Re: 1850's Unitarian Church Exterior Restoration
Project No. 96072

Re: Circa 1851 Unitarian Church
Project 96072

Re: Circa 1851 Unitarian Church
Project No. 96072

Re: 1851 Unitarian Church
Project No. 96072

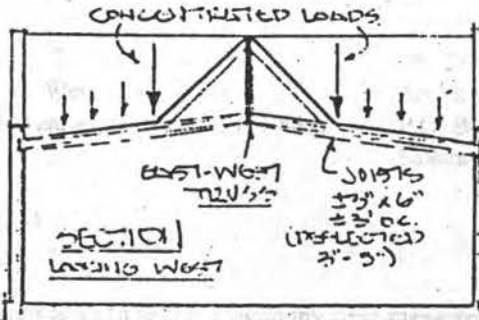
10. The historic photograph shows that the ridges of the roof-pinnacles are slightly wavy in alignment. This seems to indicate that they were made of thin sheet-metal on an armature rather than thick cast-iron sheet components. The extremely sharp points on the pinnacles are more achievable with thin-sheet fabrication than with thicker plate-metal fabrication. Mr. Guenther Huber-Delle, a master metal-craftsman here from Germany, agrees that they appear to be thin sheet-metal and has suggested a fabrication method and materials which I will detail. He recalls a couple of sheet-metal shops in Savannah that he feels would be good to do this work. The pinnacles are much simpler than those Mr. Huber-Delle has replicated on a late 19th century Synagogue and Presbyterian Church here and so he feels they will be easy to do. Each pinnacle-base will vary in exact size and squareness per my field-measurements, and the pinnacles will need to be made to fit each pier.

The profile of the base of the metal pinnacles appears to be a variation on the profile of the window hood-moulds, as would be expected in a building of this design quality. This pinnacle profile is apparently

The heights of the pinnacles and their buttress piers will be proportioned from the known dimensions of the pier stubs and the crenels. Vertical galvanized reinforcing will be detailed for the piers due to their exposure to considerable wind-load. The pinnacles will be anchored to the piers.

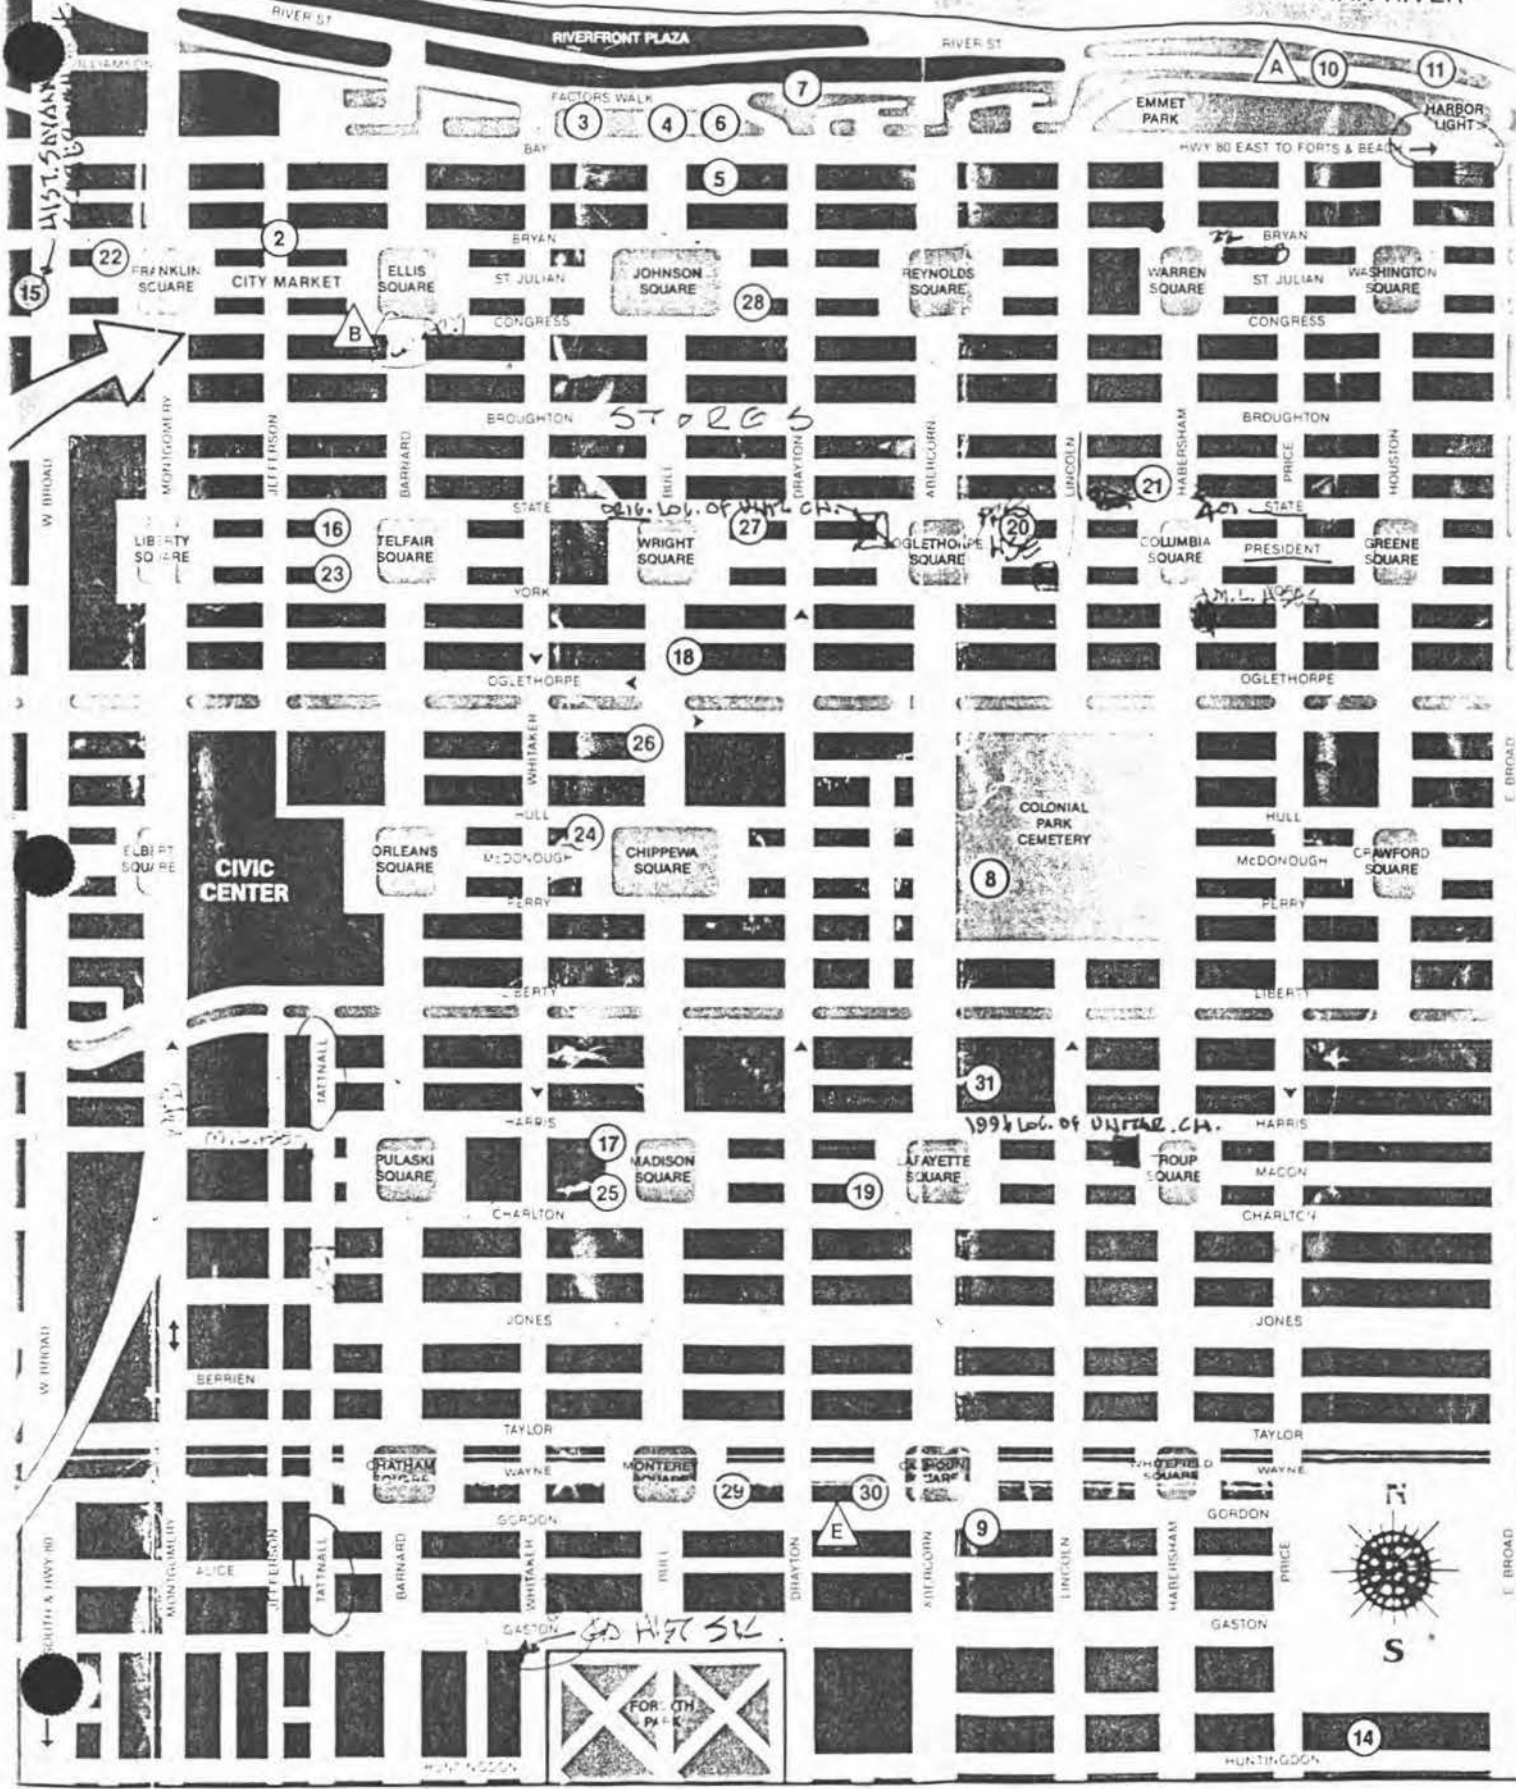
You may want to install a lightning-protection system for the Unitas Ch. The copper wires could be run down behind the finials. The system should be designed by an electrical engineer, if so. The sharp, thin rods, about $\frac{1}{4}$ " ϕ x 12" high, drain static electricity from the air & thus reduce the possibility of a lightning strike on the pointed finials. I want show this on the drawings unless I hear from you.

The design should be reviewed for visual aspects if you decide to include this system.

S. Window, east fac.
 Sashes = c. 1870-1920 (see hist. photo + p. 12 Sash w/ diamond - panes, upper rt.)

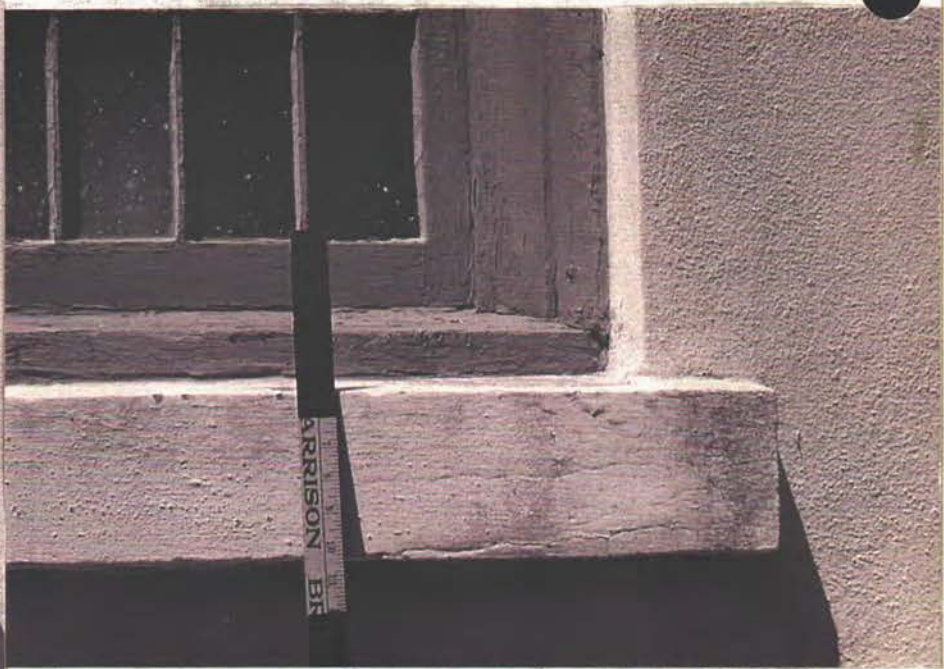
Limits of S. Mo =
 red-brown sandstone w/ white c.
 cem. patches of stress cracking & paint

1851 original
diamond-pane sash
(see hist photos)
at S. end of W. wall
of S.W. anteroom

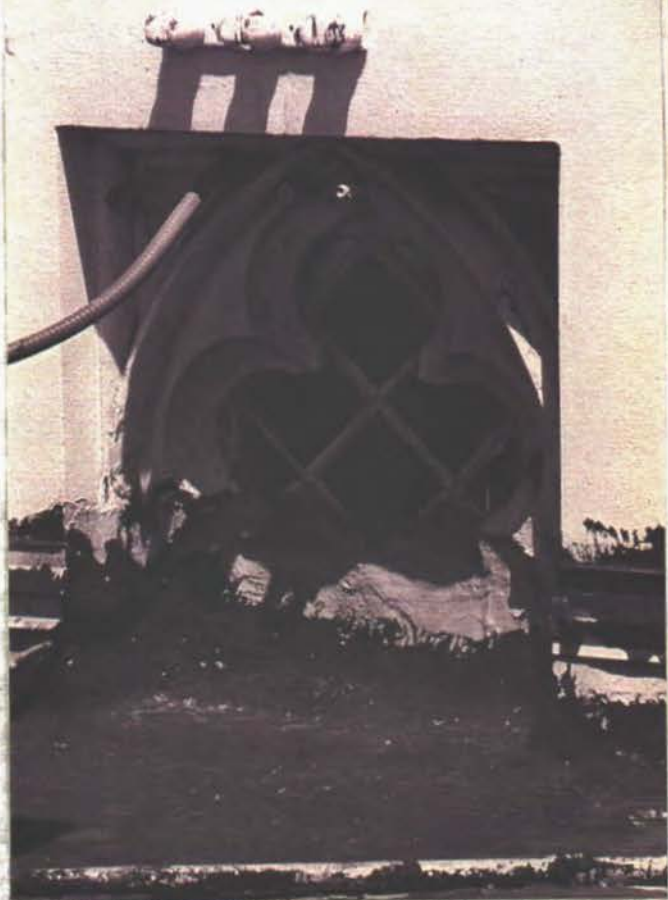
20th c. built up
roof rapped
onto sash!

Woot sash top
at S.W. anteroom
P.S. April 98 - See int. photos
of this ONLY ORIGINAL sash

ENTRY
ROOF

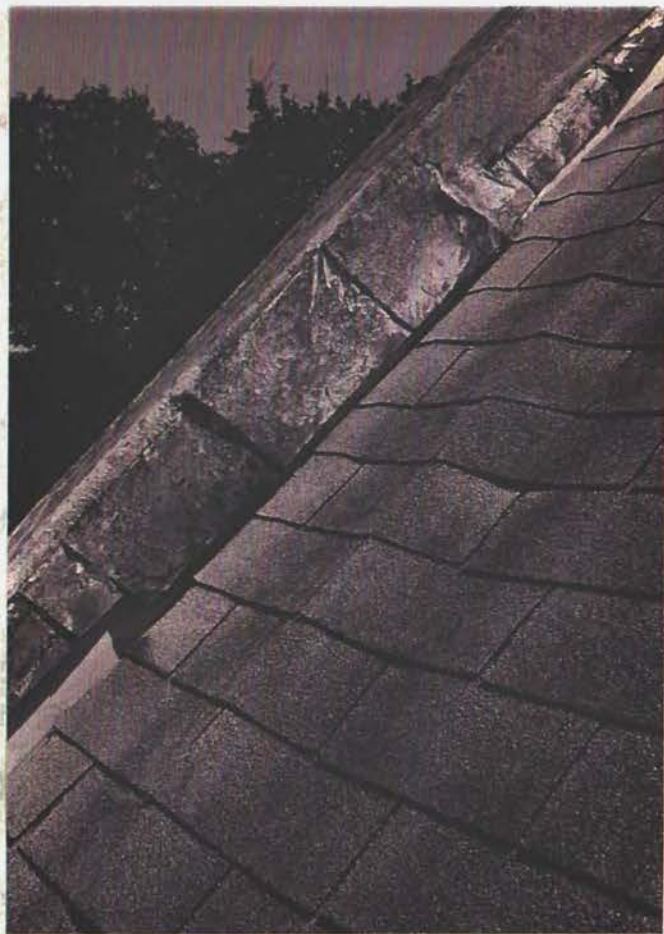
→ Rusty galv flash. - typical

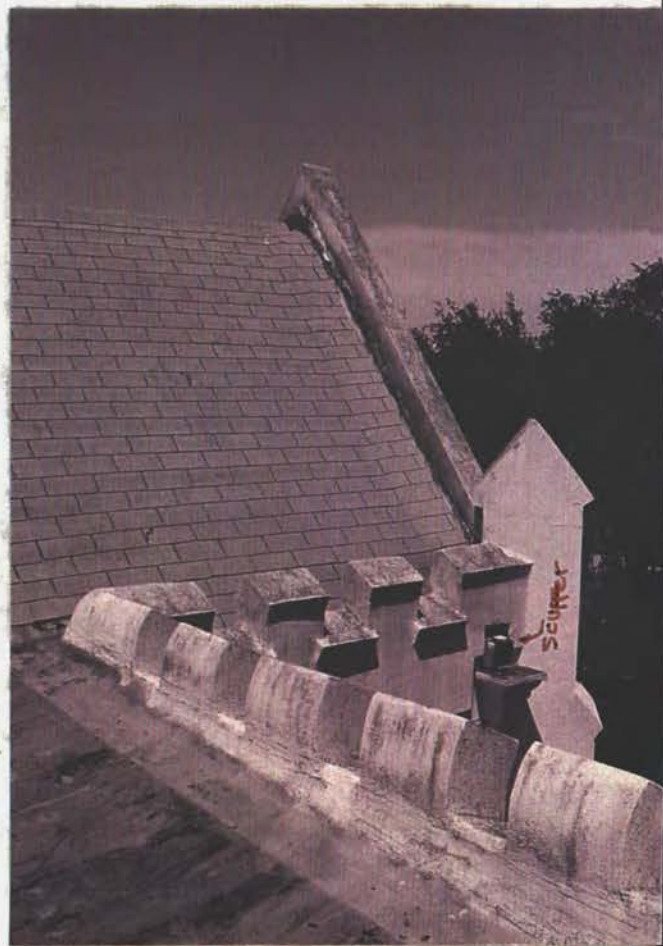
Shingles look to 10 yrs old
↓
(14 yrs. max. life)

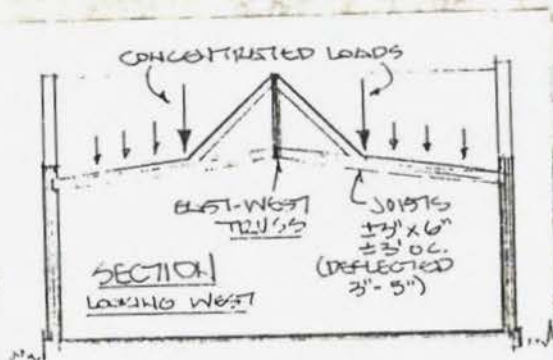
↑ Arch over balcony was to
 support the "tower" described
 in 1851 newspaper article,
 now gone
 Also is a ridge on roof where
 the tower penetrated!

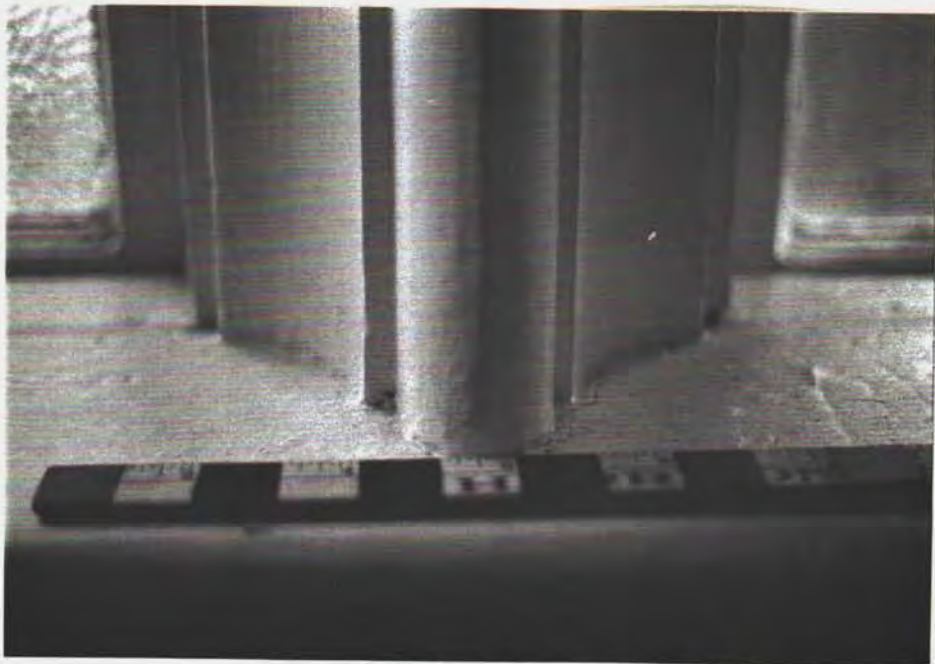
Fixed glass
(original design)
Some parts may
be orig. (?)
Ribbet - gl. pane
is 20th c.

151 Original seals
at balcony E. wall
(bottom 1/3 cut out for
a mid-20th c.
exhaust fan)

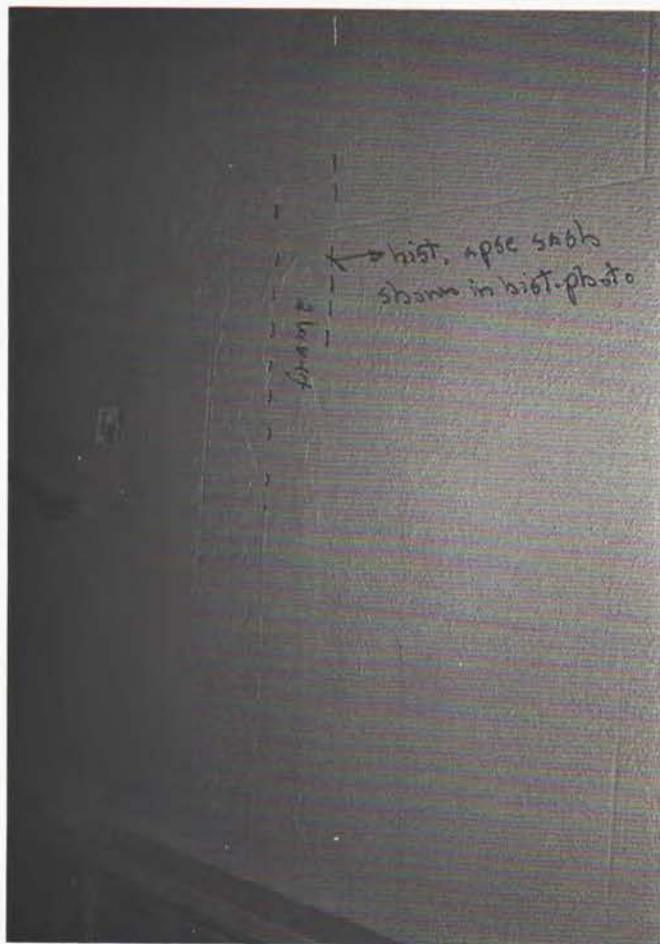
West wall of apse showing traces of plastered-over edges of 1851 apse sacbs
Shows in hist. int. photo
